# **Design review report**

Code:	AE-33285
Rev:	3
Date:	2021-01-21
Page:	1/ 8

Aim of this document is to describe suggestions and corrections that Telit advises to improve Ovoo Electronics B100AA application that integrates Telit GE910-QUAD V3 and BlueMod S50 modules.

2.1.1. Power supply

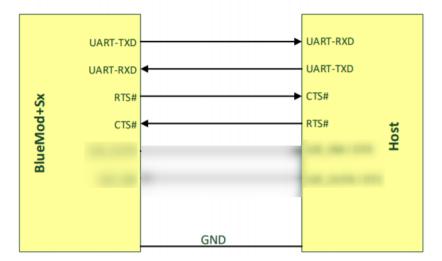
V Ok.
